DEVELOPMENT DETERMINATION PANEL MEETING

WEDNESDAY 13 NOVEMBER 2019

ITEM 3.1	DA2019/0907 - 43 QUINTON ROAD, MANLY - ALTERATIONS AND ADDITIONS TO A SEMI-DETACHED DWELLING HOUSE
REPORTING MANAGER	Matthew Edmonds
TRIM FILE REF	2019/633540
ATTACHMENTS	1 Assessment Report 2 Site Plan & Elevations

Application Number:	DA2019/0907
Responsible Officer:	Kent Bull
Land to be developed (Address):	Lot 1 DP 1072958, 43 Quinton Road MANLY NSW 2095
Proposed Development:	Alterations and additions to a semi-detached dwelling house
Zoning:	Manly LEP2013 - Land zoned R1 General Residential
Development Permissible:	Yes
Existing Use Rights:	No
Consent Authority:	Northern Beaches Council
Delegation Level:	DDP
Land and Environment Court Action:	No
Owner:	Andrew Sweeney Elizabeth Jane Sweeney
Applicant:	Andrew Sweeney Elizabeth Jane Sweeney
Application Lodged:	22/08/2019
Integrated Development:	No
Designated Development:	No
State Reporting Category:	Residential - Alterations and additions
Notified:	02/09/2019 to 16/09/2019
Advertised:	Not Advertised
Submissions Received:	0
Clause 4.6 Variation:	4.4 Floor space ratio: 14.3%
Recommendation:	Approval
Estimated Cost of Works:	\$ 82,075.00

Development standard:	Height of buildings
Requirement:	5.5m (Clause 4.3 (2FA))
Proposed:	6.4m
Percentage variation to requirement:	16.4%

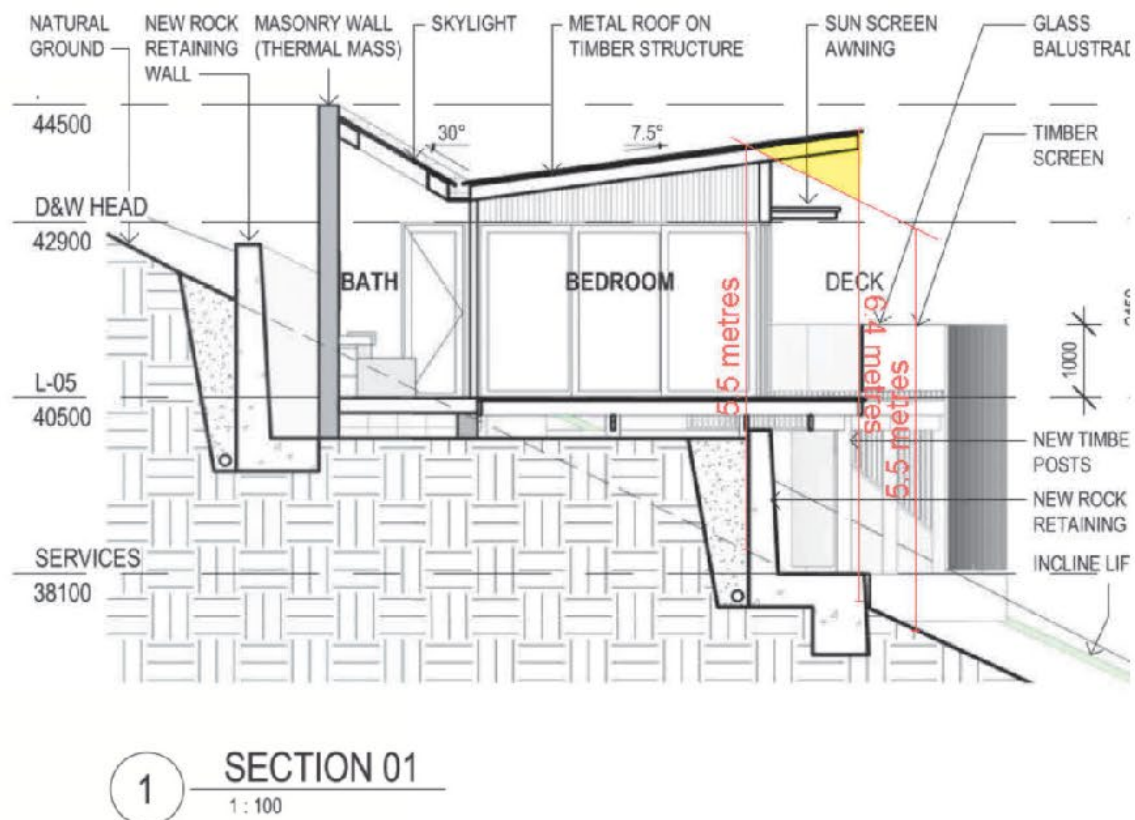
Council has reviewed the above reasons stated by the applicant and generally agree with the statements made regarding the proposal, except for the assertion by the applicant that the maximum ridge height is RL 40.5, as the plan shows a ridge height of RL44.5. However, as stated by the author of

C1.19 Incline Passenger Lifts and Stairways

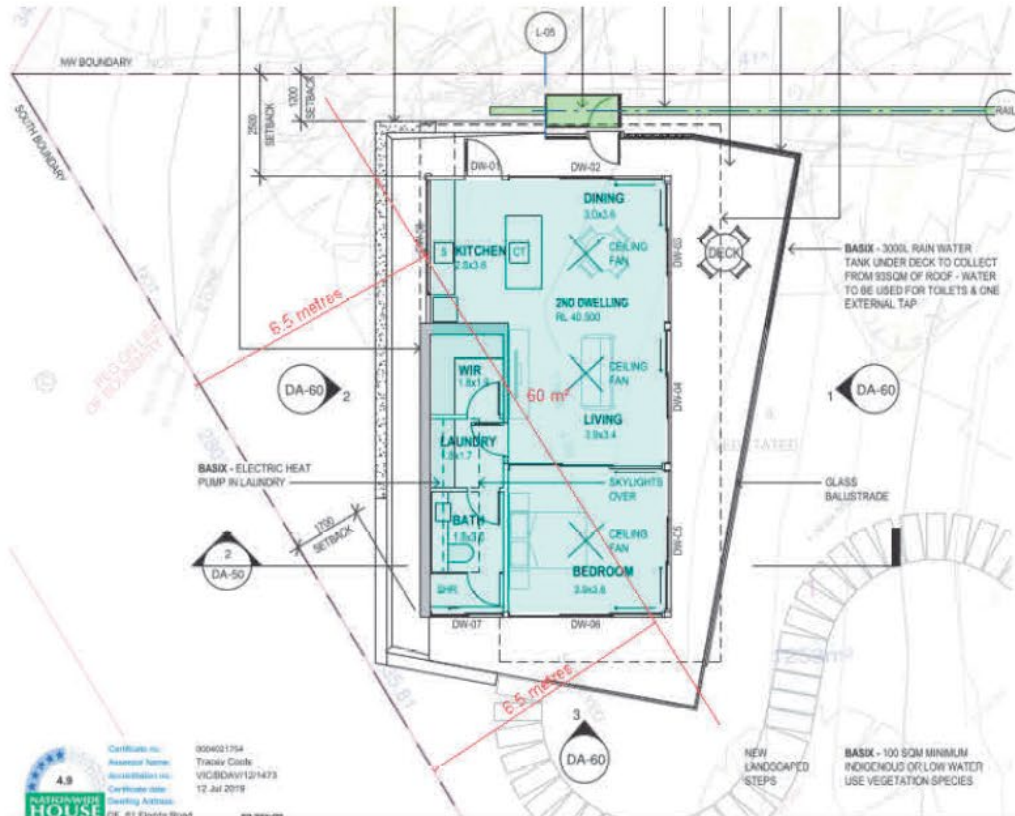
The DCP control requires incline passenger lifts to have a setback of 2m measured to the outside face of the carriage. The proposed passenger lift has a setback of 0.5m from the outside face of the carriage. Although non-compliant with the numerical control, the following considerations are taken into account in the assessment of the location:

- The location of the incline passenger lift has been located to minimise disturbance to the existing trees on the site. For example, should the carriage move further from the boundary this would create an impact on T8 Cheese Tree;

- Beyond the boundary adjoining the incline passenger lift is a vacant unformed council reserve which is approximately 6m in width. This reserve comprises of largely un-maintained vegetation and acts as an additional buffer between the next residential property 85 Florida Street. This additional spatial separation assists in mitigating any visual impact of the lift from the adjoining property and minimises opportunity for overlooking from the lift.
